**ECONOMIC COMMISSION FOR EUROPE**  
**INLAND TRANSPORT COMMITTEE**  
World Forum for Harmonization of Vehicle Regulations (WP.29)  
Working Party on Noise and Tyres (GRBP)  
Task Force on Vehicles' Sound (TF-VS)

## Draft Report of the 09<sup>th</sup> Session of the Task Force on Vehicles Sound TF-VS On Tuesday 24<sup>th</sup> May from 10:00 to 16:00 (CET)

### a.1. (EC) studies on vehicles' sound emissions for M, N vehicles' noise (HS Data Analysis and Consultancy-TNO-Aristotle University of Thessaloniki)

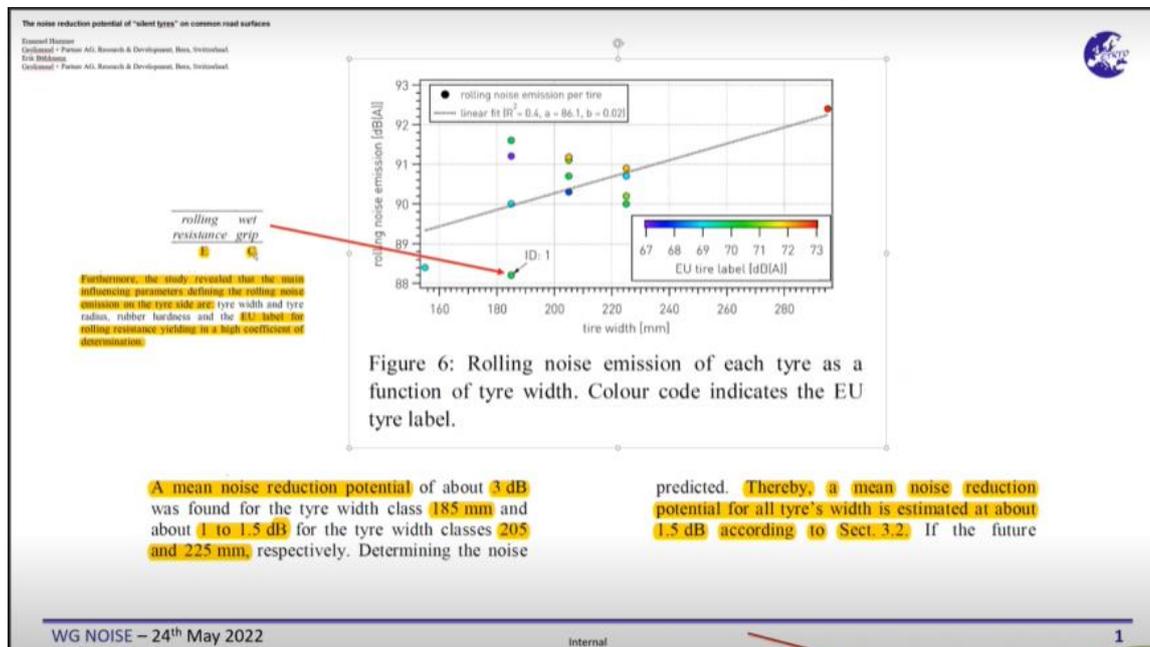
- Slide 31: in the part related to the 'Intake orifice & rest', the 'rest part' is the dominant factor.
- Through the sample tested for N3 vehicles, the type of tyre is not such a big issue.
- It was reminded especially for heavy vehicles that the technical decision related to the measurement procedure was done ~20 years ago to accommodate how the vehicles were really driven in traffic. It was the goal of the new test procedure. Tests for passenger cars and heavy vehicles are different.

M1 vehicles have a wide-open throttle test and a cruise test for the purpose of approximating the partial throttle, which is how they really drive.

Same for heavy commercial vehicles. They really drive more up at the higher engine speeds with decision at that time with full acceleration test for the heavy vehicles.
